PROJECT
Proposed Res. Dev., at Land off Puddingpoke Lane, Lutton, Lincs., for D & H Builders Ltd.

TITLE
Longitudinal Sections

DRG No. 33202/03 REV A

Proposed Site Plan
Planning & Development
11 JAN 2003

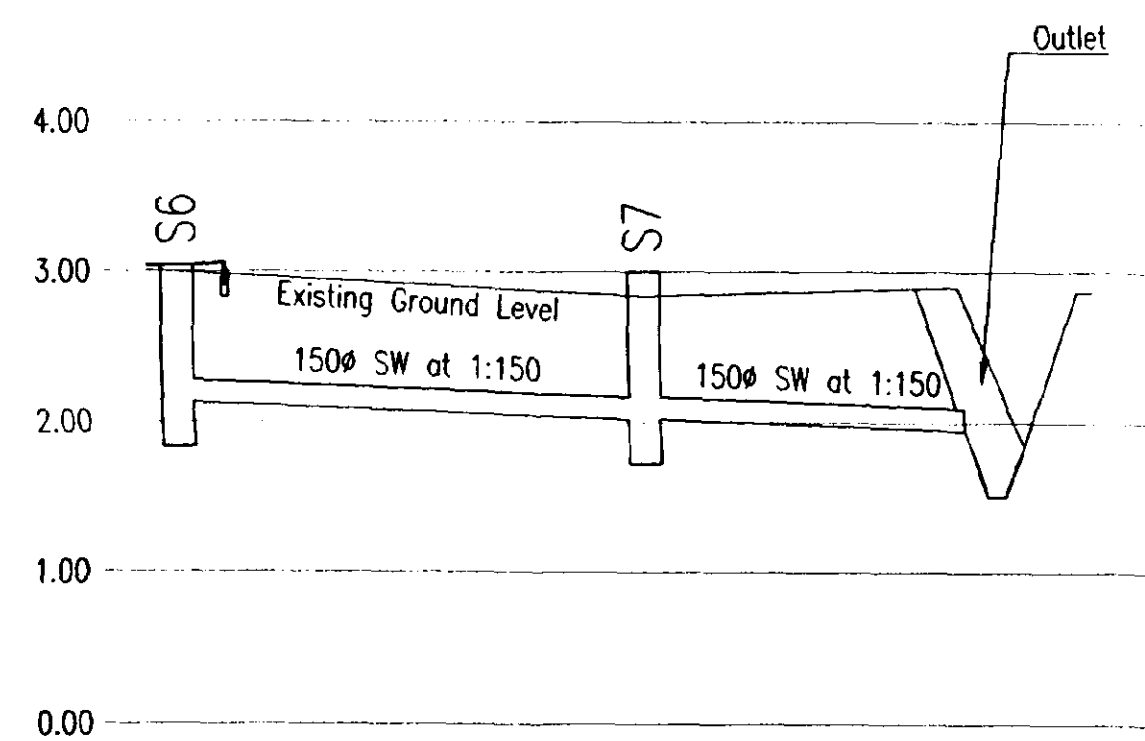
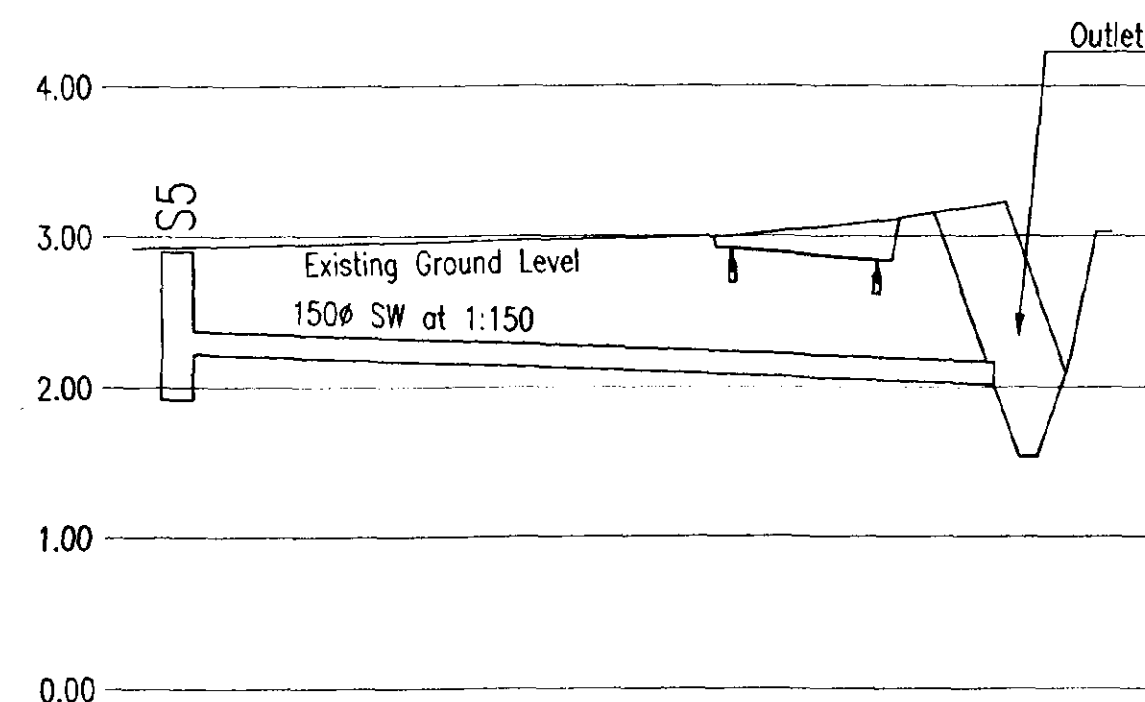
REV	DATE	REMARKS
A	20/11/02	Surface water manhole positions amended between pipe runs S3 and S1. Surface water manhole S1a added. Proposed site/ road levels amended local to entrance off Lowgate. Longitudinal sections updated.

DRG No. 33202/01

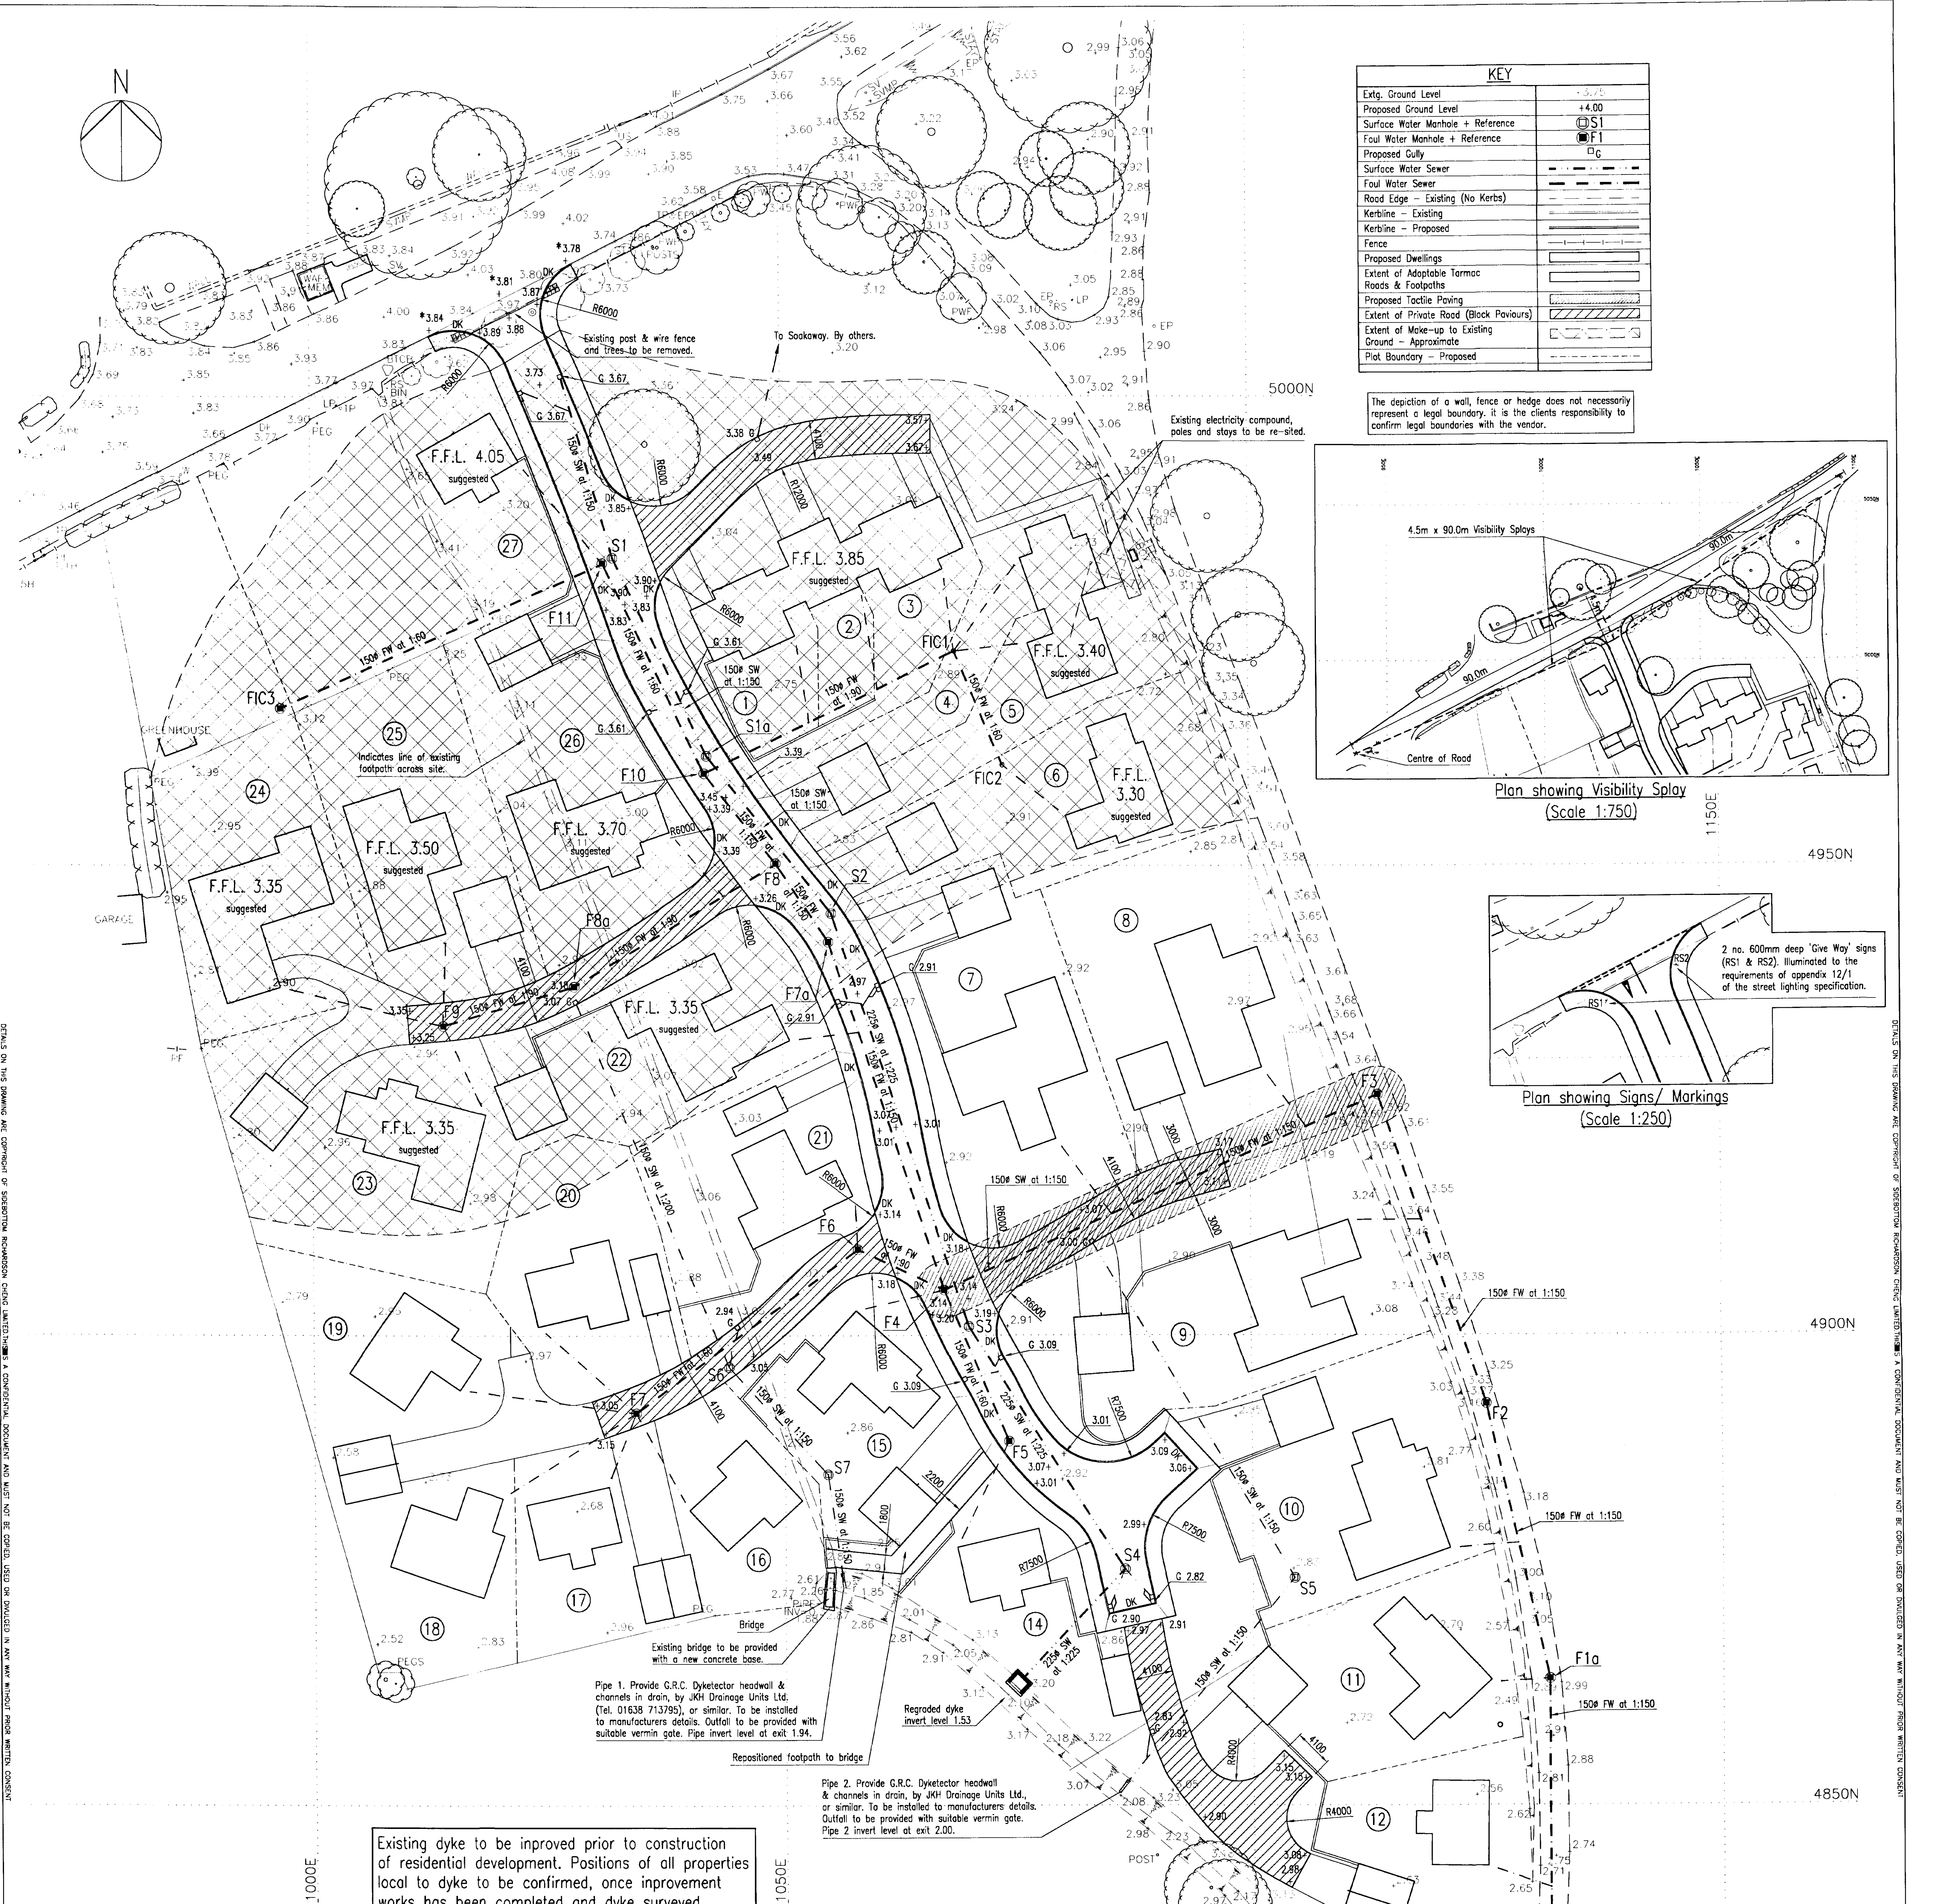
REV	DATE	REMARKS
1	20/11/02	Visually spray omitted to match Status drawings no. 93002/1, approved by L.C.
2	10/12/02	Amended to LCC comments received 1. Visually spray omitted. Signs added. 2. No illuminated 'give way' signs. Double gates shown at turning point to mention S3. Note added that footpaths to receive new concrete base. 3. Full water sewer omitted to AWS car parking area. 4. Full water sewer omitted to F1 to F2 omitted. Surface water manholes omitted. Proposed site/ no omitted. 5. Full water sewer omitted. Drop added.
